CUSTODIAN: E-25		PROCUREMENT SPECIFICATION: AS7467 /3/	
	AEROSPACE STANDARD BOLT, MACHINE, DOUBLE HEXAGON EXTENDED WASHER HEAD, CLOSE TOL. SHANK, UNS N07718, 185 KSI MIN, .3125-24 UNJF-3A (STRESS RUPTURE RESISTANT)		AS3419™ SHEET 1 OF 3
			REV. D

ISSUED 1985-12 REAFFIRMED 2006-05 REVISED 2022-08

FIGURE 1 - BOLT

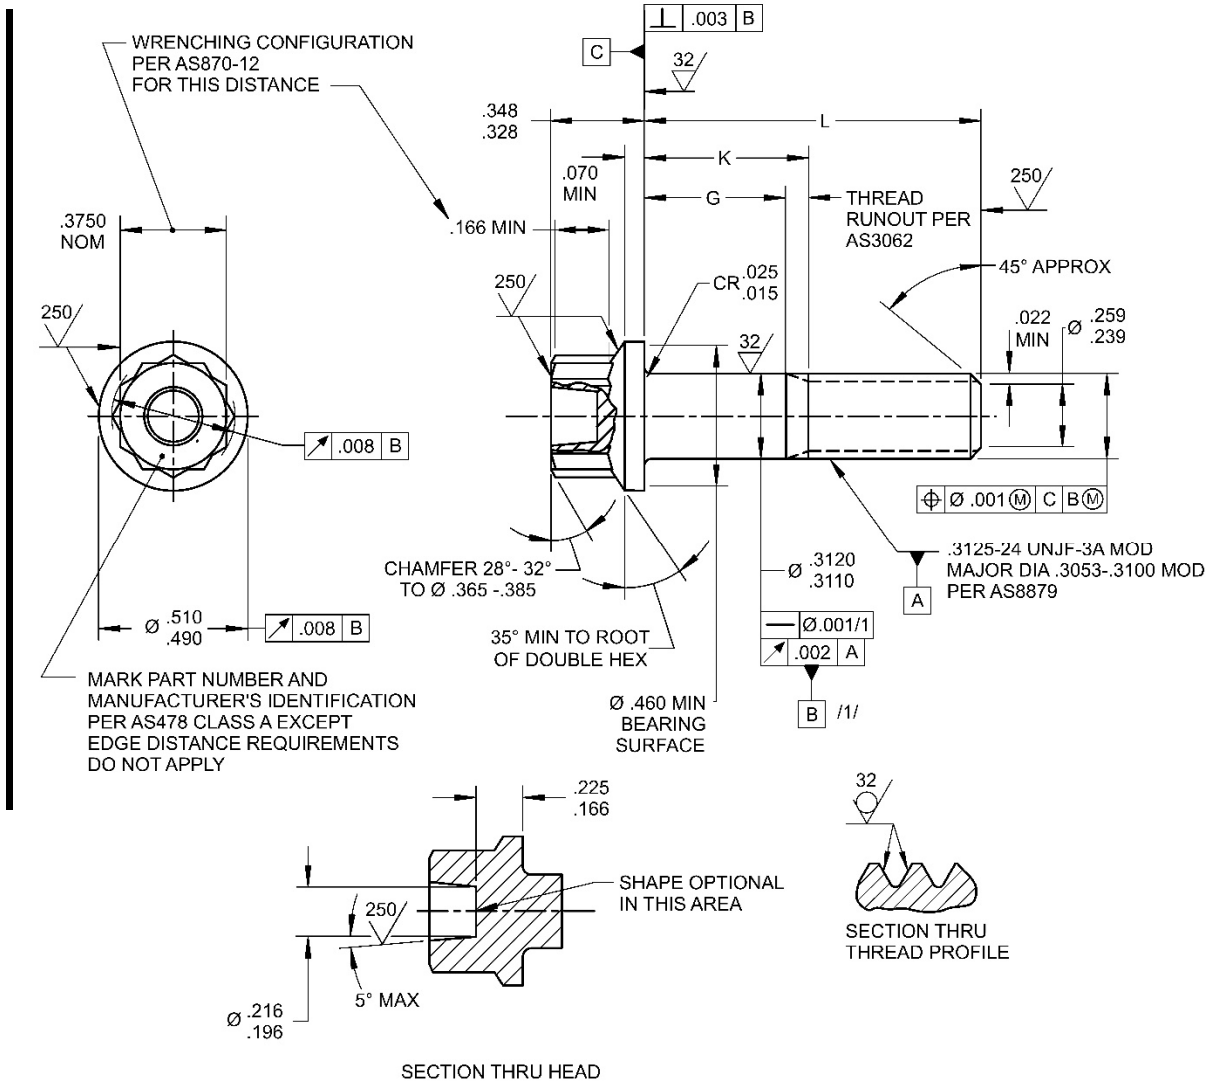
UPDATE TO ASME Y14.5-2018. UPDATE LEAD THREAD CHAMFER TO AS1132. REVISE POSITION FCF ON MAJ DIA TO INCLUDE NEW DATUM C PER AS1132. REVISE LIGHTENING HOLE CONFIGURATION TO AS1132. REVISE HEAD TO SHANK FILLET TO CR. ADD "COMPOSITION SIMILAR TO" TO UNS IN NOTE 2. GENERAL EDITORIAL UPDATES.
